SUBJECT: LASALLE COUNTY STATION, UNITS 1 AND 2 - STAFF ASSESSMENT OF INFORMATION PROVIDED PURSUANT TO TITLE 10 OF THE *CODE OF FEDERAL REGULATIONS* PART 50, SECTION 50.54(f), SEISMIC HAZARD REEVALUATIONS FOR RECOMMENDATION 2.1 OF THE NEAR-TERM TASK FORCE REVIEW OF INSIGHTS FROM THE FUKUSHIMA DAI-ICHI ACCIDENT (TAC NOS. MF3881 AND MF3882)

STAFF ASSESSMENT BY THE OFFICE OF NUCLEAR REACTOR REGULATION

RELATED TO SEISMIC HAZARD AND SCREENING REPORT

LASALLE COUNTY STATION, UNITS 1 AND 2

Figure 3.3-1: Plot of Staff's and Licensee's Base Case Shear-Wave Velocity Profiles for LaSalle County Station

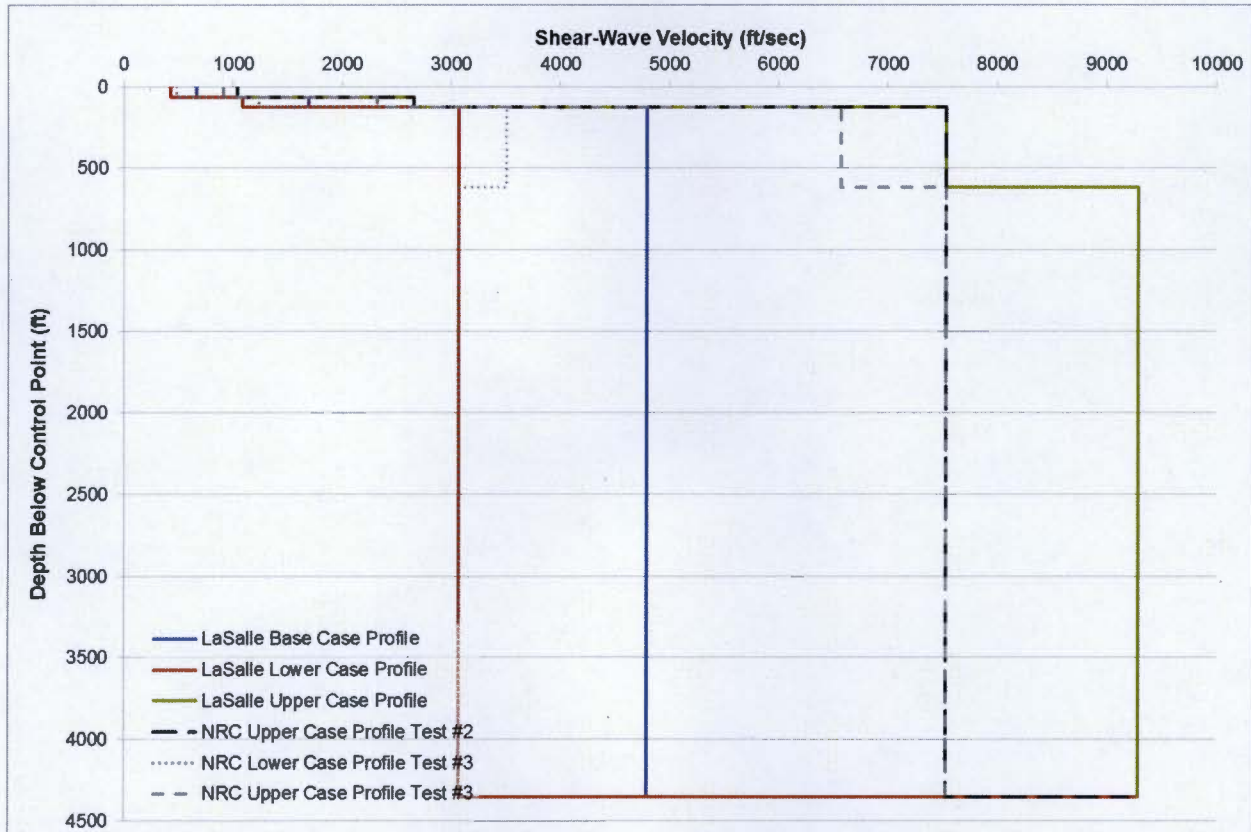
The licensee developed three base-case shear-wave velocities for the LaSalle site. The licensee used a natural log standard deviation of 0.35 to calculate the lower and upper base case shear-wave velocity profiles with one variation. The licensee varied the upper base case profile to increase the shear-wave velocity between 616 ft (188 m) and 4,400 ft (1341 m) to 9,285 ft/sec (2,830 m/s). Table 2.3.2-1 and Figure 2.3.2-1 of the SHSR provide the licensee's shear-wave velocity profile for each of the three base cases. Figure 3.3-1 of this assessment shows the licensee's three shear-wave velocity base case profiles.

The staff conducted three confirmatory calculation tests of the licensee's site response analysis. For its first confirmatory analysis, the staff calculated the site response using all of the licensee's inputs. For its second analysis, the staff calculated the site response using all of the licensee's inputs, except the staff determined both the upper and lower base case shear-wave velocity profiles using a natural log standard deviation of 0.35 and did not, as the licensee did, increase the shear-wave velocity of the upper base case profile to 9,285 ft/sec (2,830 m/s) over the profile depths between 616 ft (188 m) and 4,400 ft (1341 m). Finally for its third analysis, the staff used a lower natural log standard deviation of 0.20 to calculate the lower and upper shear-wave velocity profiles for all layers less than 616 ft (188 m) in the profile and a natural log standard deviation of 0.35 for the layers below 616 ft (188 m). Similar to the licensee, the staff randomized its lower, base, and upper case shear-wave velocity profiles using the guidance provided in the Appendix B of the SPID in order to account for aleatory variability. In addition, to capture the uncertainty in the depth to base rock, the staff randomized the depth to bedrock by $\pm 1,320$ ft (± 402 m), which corresponds to 30 percent of the total profile thickness and is consistent with the licensee's analyses. In Figure 3.3-1 of this assessment, the staff compared the licensee's base case profiles to those modified by the staff during confirmatory analysis tests.

Figure 3.3-2 Plot Comparing the Staff's and the License's Median Amplification Functions and Uncertainties for two input loading levels for LaSalle County Station

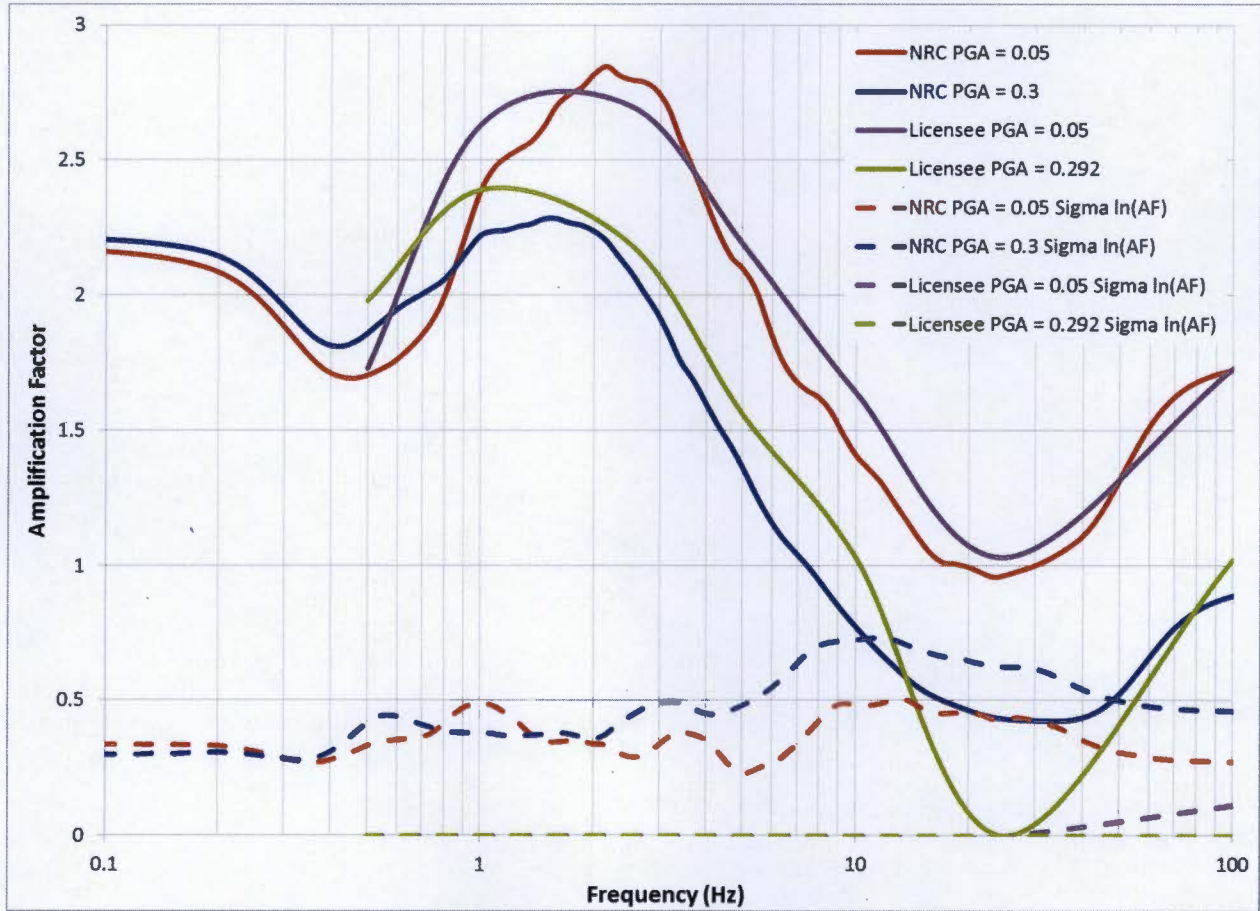
Figure 3.3-2 of this assessment shows a comparison of the staff's and licensee's median site amplification factors and uncertainties (± 1 standard deviation) for two of the eleven input loading levels. The staff's median site amplification factors are similar to the licensee's but somewhat below the licensee's amplification factors between 0.8 and 100 Hz. Below 0.8 Hz, the staff's amplification factors are higher than the licensee's. However, at frequencies below 0.8 Hz, both the staff and licensee's final GMRS are approximately equal to or lower than the site SSE spectrum.

Figure 3.3-3 Plot Comparing the Staff's and the Licensee's Mean Control Point Hazard Curves at a Variety of Frequencies for LaSalle County Station

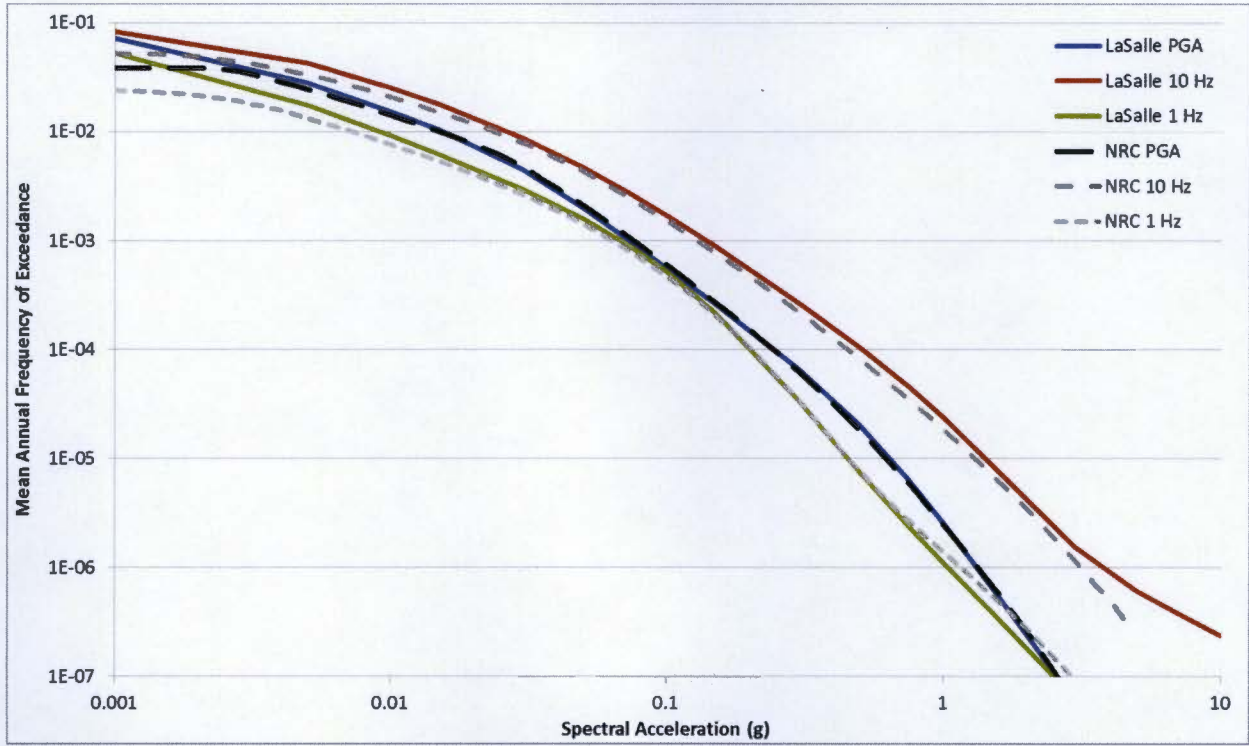
Overall, the licensee's approach to modeling the subsurface rock properties and their uncertainty results in somewhat higher site amplification factors, than did the staff's analysis. However, as shown in Figure 3.3-3 of this assessment, the staff notes that these differences in the site response analysis do not have a large impact on the control point seismic hazard curves or the resulting GMRS, as discussed below. Appendix B of the SPID provides guidance for performing site response analyses, including capturing the uncertainty for sites with less subsurface data; however, the guidance is neither entirely prescriptive nor comprehensive. As such, various approaches in performing site response analyses, including the modeling of uncertainty, are acceptable for this application.

Figure 3.4-1 Comparison of the Staff's GMRS, Licensee's GMRS, and the SSE for LaSalle County Station

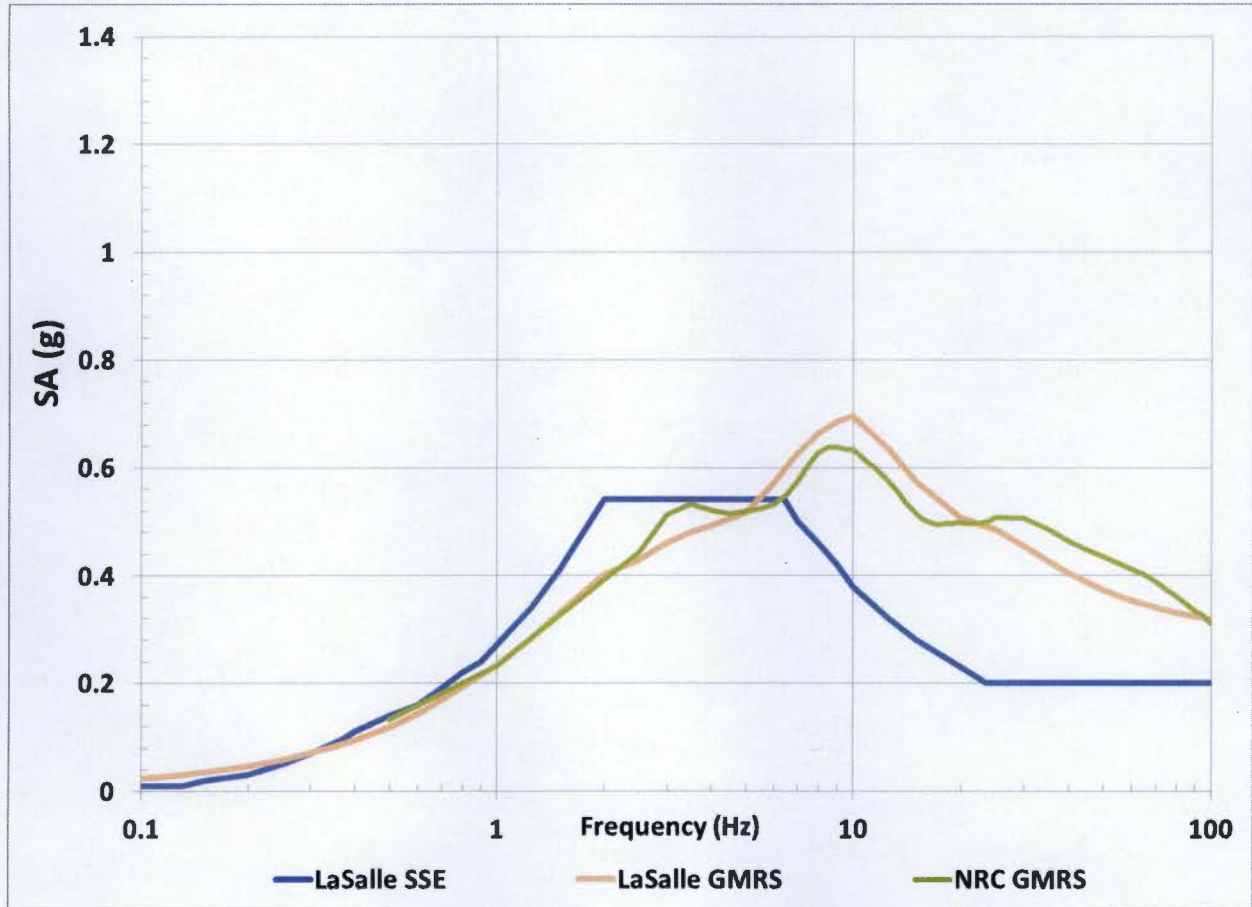
The staff independently calculated the 10^{-4} and 10^{-5} UHRS using the results of its confirmatory PSHA and site response analyses, as described in Sections 3.2 and 3.3 of this staff assessment, respectively. Figure 3.4-1 of this assessment shows a comparison of the GMRS determined by the licensee to that determined by the staff.

As shown in Figure 3.4-1 of this assessment, the licensee's GMRS is very similar to the staff's confirmatory GMRS. The staff concludes that the small differences between the two GMRS are acceptable because the licensee followed the guidance provided in the SPID with respect to both the PSHA and site response analysis for the LaSalle site for the response to the 50.54(f) letter.
